RE: Oconee Unit 1  
Docket No. 50-269

Please find attached for your review proposed changes to the Oconee Nuclear Station Technical Specifications. The purpose of these revisions is to ensure operation of the Oconee Unit 1, Cycle 2 Core within appropriate fuel design criteria and LOCA limits. Proposed changes are shown in Attachment 1 as replacement pages for the Oconee Nuclear Station Technical Specifications:

ATTACHMENT 1

PROPOSED TECHNICAL SPECIFICATION REPLACEMENT PAGES

Figure 2.1-1A

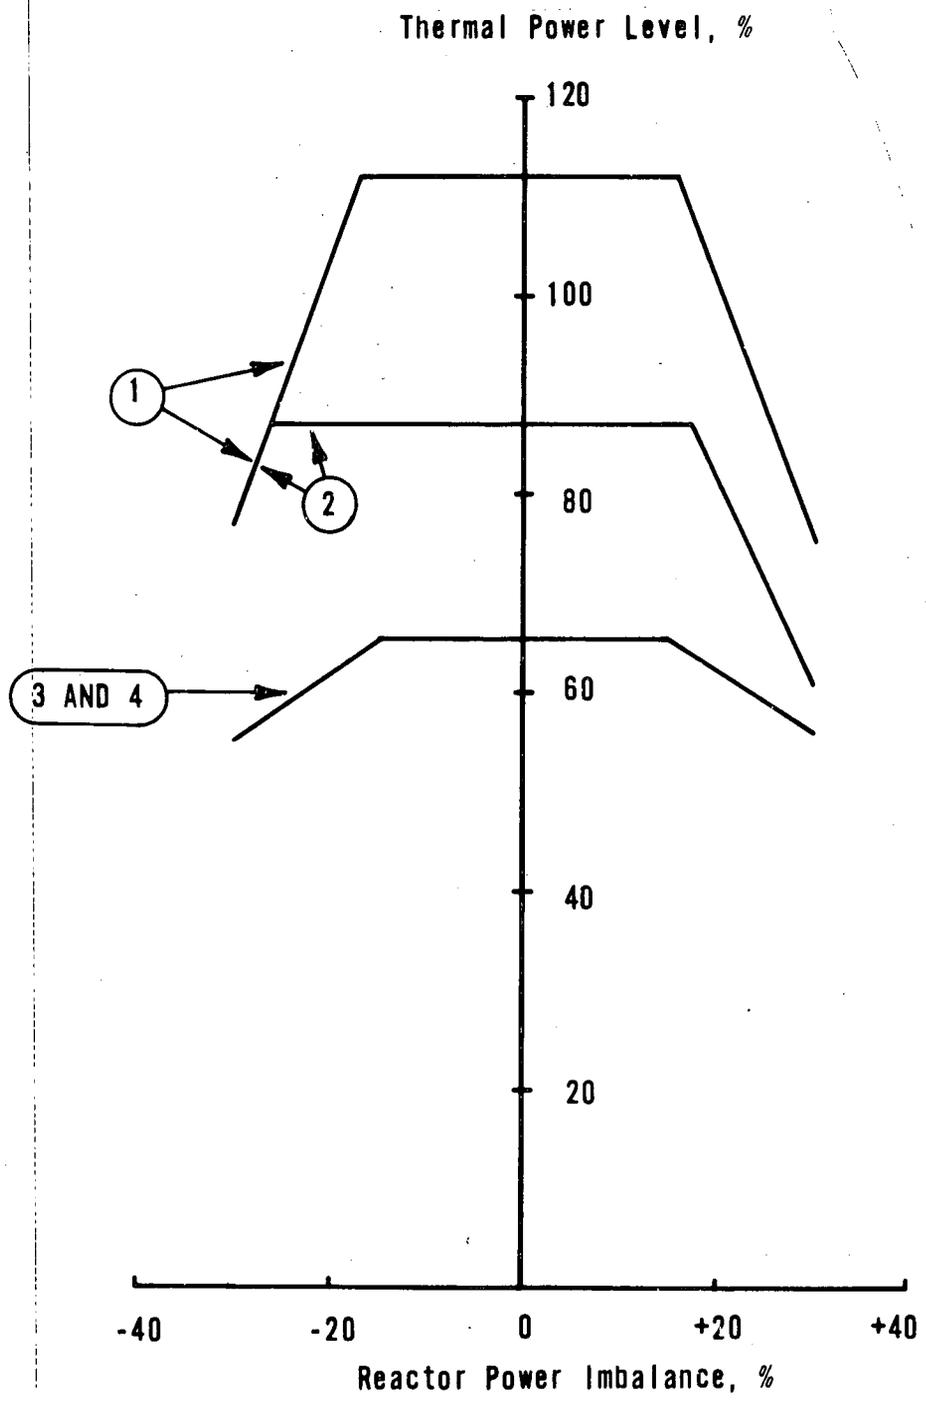
The curve presented in Figure 2.1-1A represents the conditions at which a  
2.1-1B  
2.1-1C

minimum DNBR of 1.3 is predicted for the maximum possible thermal power (112%) when four reactor coolant pumps are operating (minimum reactor coolant flow is  $131.3 \times 10^6$  lbs/hr.) This curve is based on the following nuclear power peaking factors(2) with potential fuel densification effects;

$$F_q^N = 2.67; F_{\Delta H}^N = 1.78; F_z^N = 1.50$$

Figure 2.1-2A

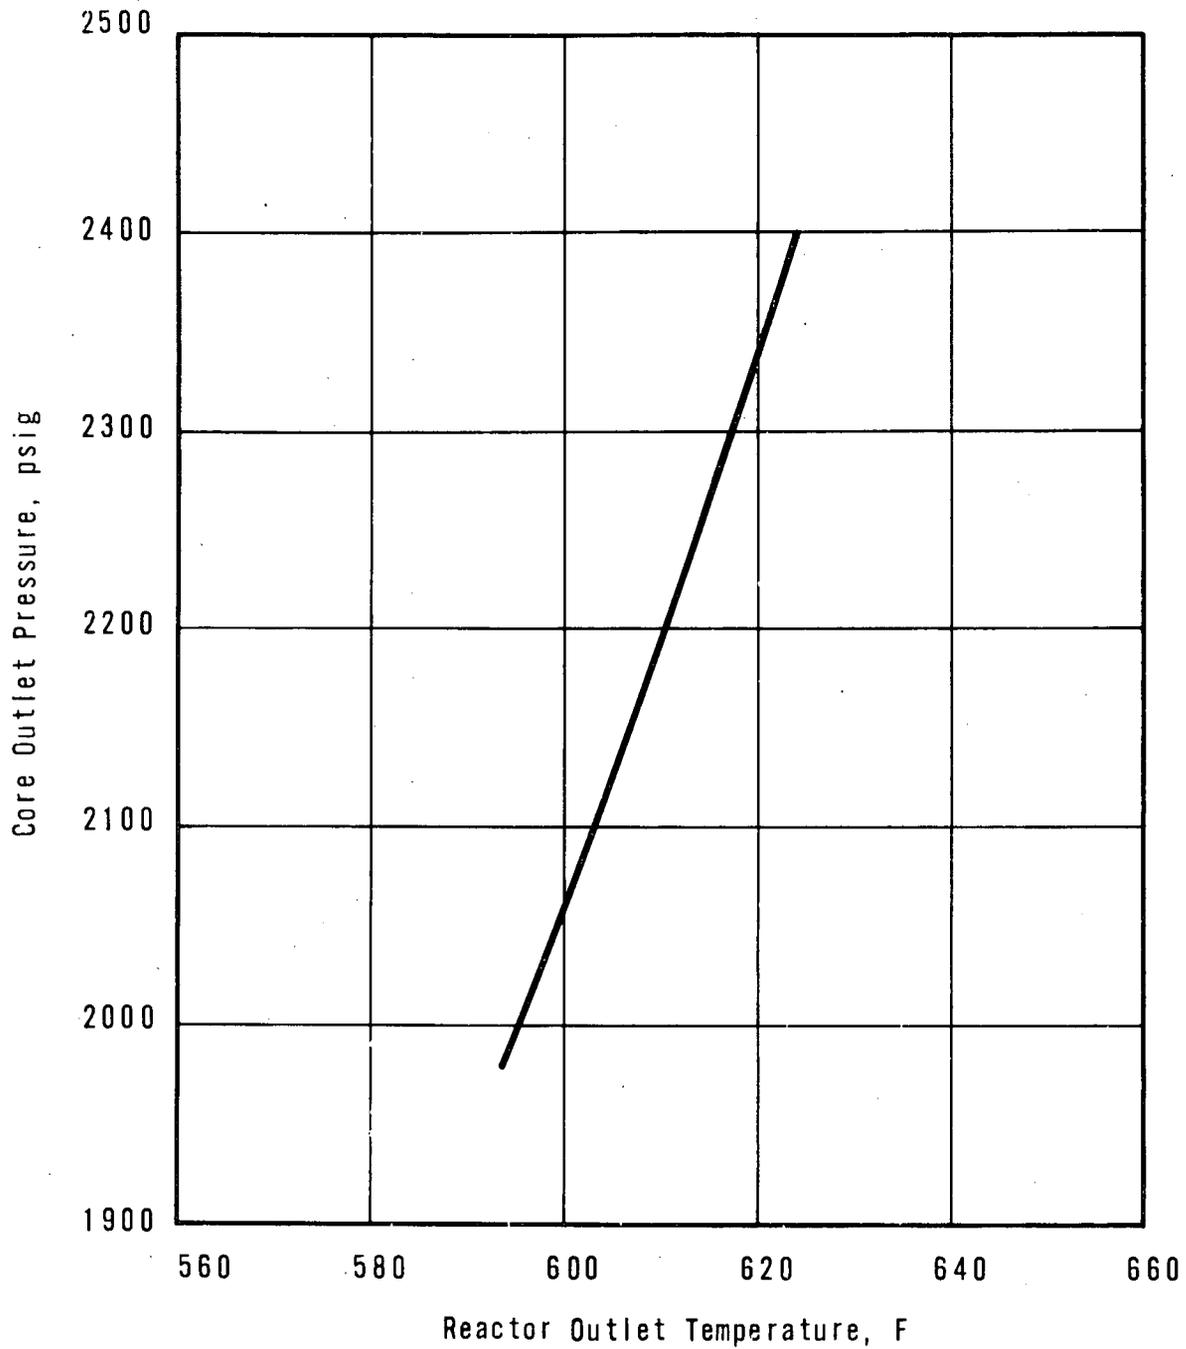
The curves of Figure 2.1-2A are based on the more restrictive of two thermal  
2.1-2B  
2.1-2C

limits and include the effects of potential fuel densification:

1. The 1.3 DNBR limit produced by a nuclear power peaking factor of  $F_q^N = 2.67$  or the combination of the radial peak, axial peak and position of the axial peak that yields no less than a 1.3 DNBR.
2. The combination of radial and axial peak that causes central fuel melting at the hot spot. The limit is  
20.15 kw/ft - Unit 1  
19.8 kw/ft - Unit 2  
19.8 kw/ft - Unit 3

The specified flow rates for Curves 1, 2, 3, and 4 of Figure 2.1-2A correspond  
2.1-2B  
2.1-2C

to the expected minimum flow rates with four pumps, three pumps, one pump in each loop and two pumps in one loop, respectively.

Figure 2.3-2A2

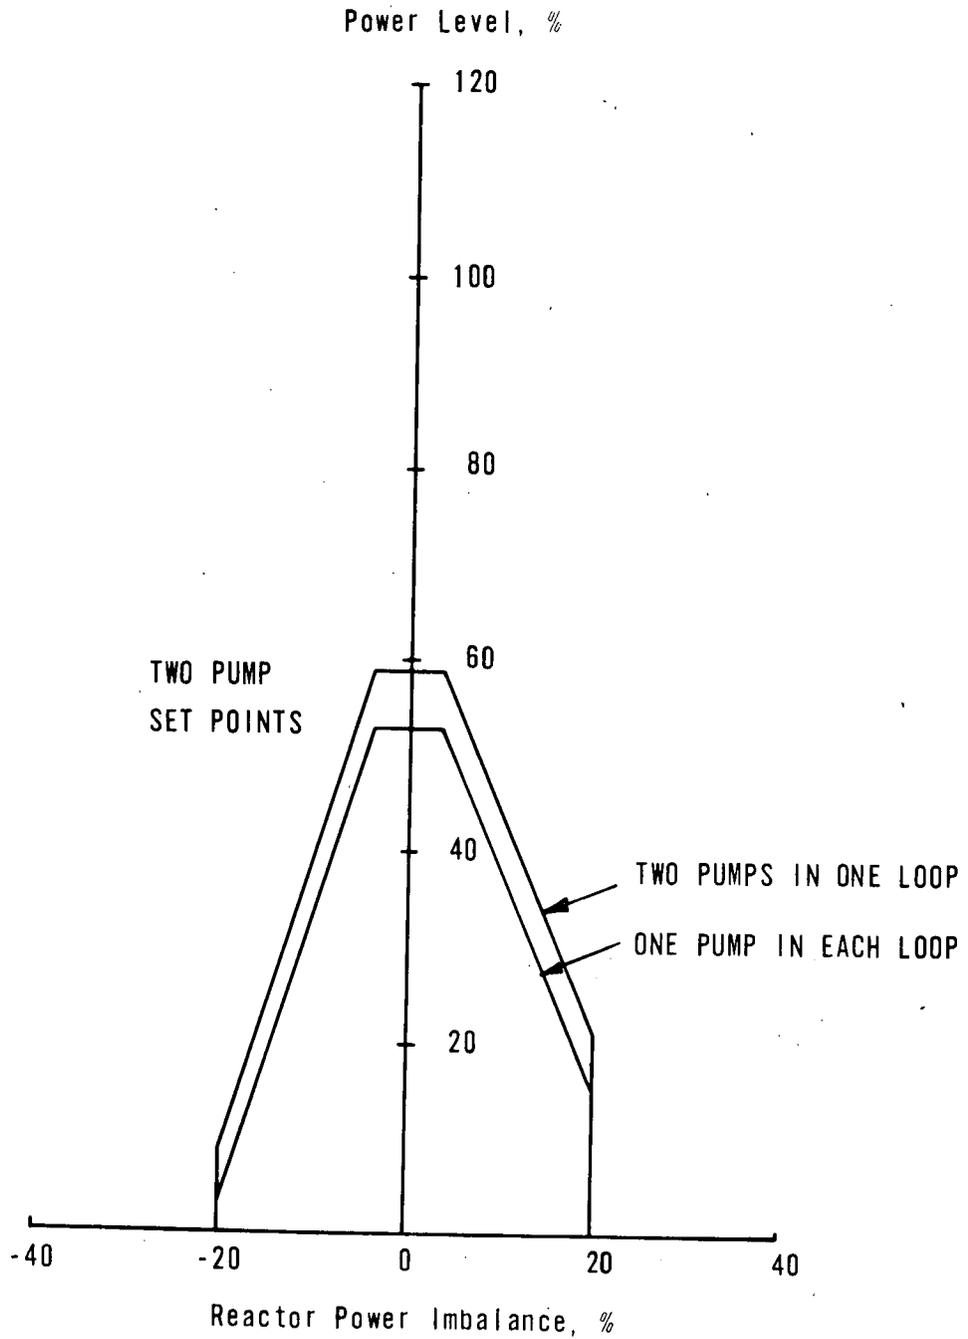
1. Reset the pump contact monitor power level trip setpoint to 55.0%.
2. (Unit 1) Reset the protective system maximum allowable setpoint as shown in Figure 2.3-2A2.

1. Reset the pump contact monitor power level trip setpoint to 55.0%.
2. Trip one of the two protective channels receiving outlet temperature information from sensors in the Idle Loop.
3. (Unit 1) Reset the protective system maximum allowable setpoints as shown in Figure 2.3-2A2. Tripping one of the two protective channels receiving outlet temperature information from the idle loop assures a protective system trip logic of one out of two.

Figure 3.5.2-1A1

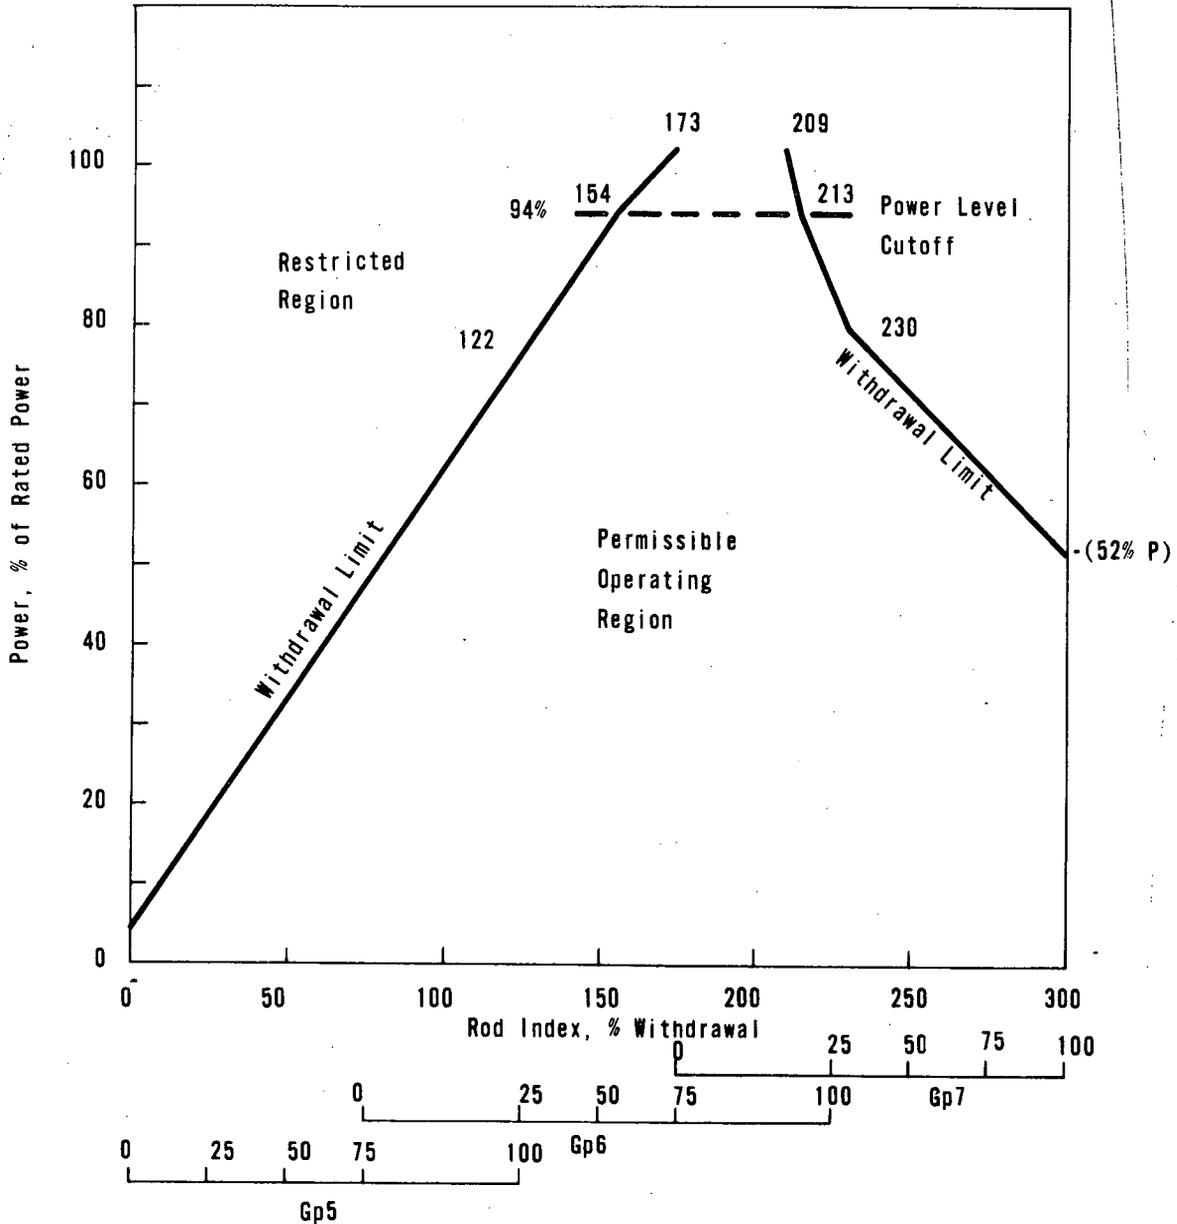
1. Rod index is the percentage sum of the withdrawal of the operating groups.
2. The withdrawal limits are modified after  $250 \pm 5$  full power days of operation.
